SOLICITATION AMENDMENT
MODIFICATION DE L'INVITATION

Title - Sujet MUAV SYSTEMS	
Solicitation No. - N° de l'invitation W8476-133748/B	Amendment No. - N° modif. 002
Client Reference No. - N° de référence du client W8476-133748	Date 2013-06-17
GETS Reference No. - N° de référence de SEAG PW-\$\$RA-053-23769	
File No. - N° de dossier 053ra.W8476-133748	CCC No./N° CCC - FMS No./N° VME
Solicitation Closes - L'invitation prend fin at - à 02:00 PM on - le 2013-07-08	
F.O.B. - F.A.B. Specified Herein - Précisé dans les présentes Plant-Usine: <input type="checkbox"/> Destination: <input type="checkbox"/> Other-Autre: <input checked="" type="checkbox"/>	
Address Enquiries to: - Adresser toutes questions à: Springs(ra div.), Brent	Buyer Id - Id de l'acheteur 053ra
Telephone No. - N° de téléphone (819) 956-7889 ()	FAX No. - N° de FAX (819) 956-0636
Destination - of Goods, Services, and Construction: Destination - des biens, services et construction:

This Solicitation Amendment 02 is raised for **MUAS QUESTIONS AND ANSWERS.**

Figure 1 – Outside view of the Tactical Vest left and right panels

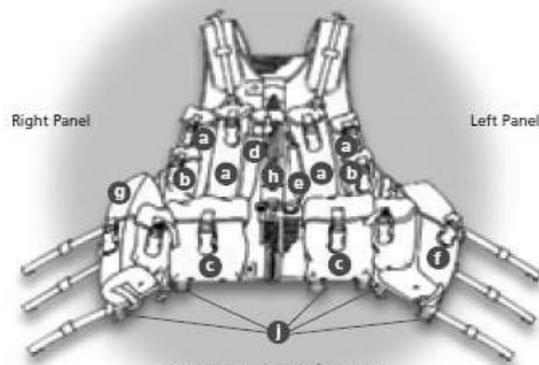
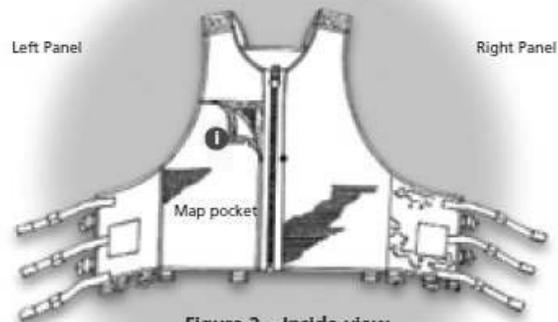
(3.4.2.h.i) Can you provide details on the CF load carrying vest?

Answer: The current (2001) CF Tactical Vest (TV) has been designed specifically for the Canadian Soldier by a load carriage design team and validated by Army Field Forces user trials. The TV is designed to provide load carriage for various missions. Pockets and pouches are sewn on to a mesh, which provides ventilation. The wide shoulder straps help to disperse the load over a wide area thereby avoiding pressure points. As the main component of fighting order, its

primary function is to carry ammunition and water for immediate combat. The TV is available in two sizes, Medium and Large. It is adjustable to accommodate the full range of individual operational combat clothing configuration from combat shirt alone to middle layer of the Improved Environmental Clothing System (IECS) or the Integrated Clothing Ensemble (ICE) with Fragmentation Protective Vest and Bullet Resistant Plates. (See figures below)

- a. Four C7 Magazine pockets
- b. Two High Explosive (HE) Fragmentation Grenade pockets M67
- c. Two field dressing / all-purpose utility pockets with snow cuff
- d. A Flashlight pocket (for mini-MagLite™ or equivalent) with coloured lens holder
- e. A whistle (NSN 8465-21-104-7964) pocket
- f. C9-200 Round Belt Box Magazine pouches with smoke grenade pocket
- g. Water Bottle pouches with smoke grenade pocket
- h. Sternum mounted bayonet
- i. Map/combat ration pocket
- j. Alternate attachment point for C4 NBC Mask Carrier vice sling
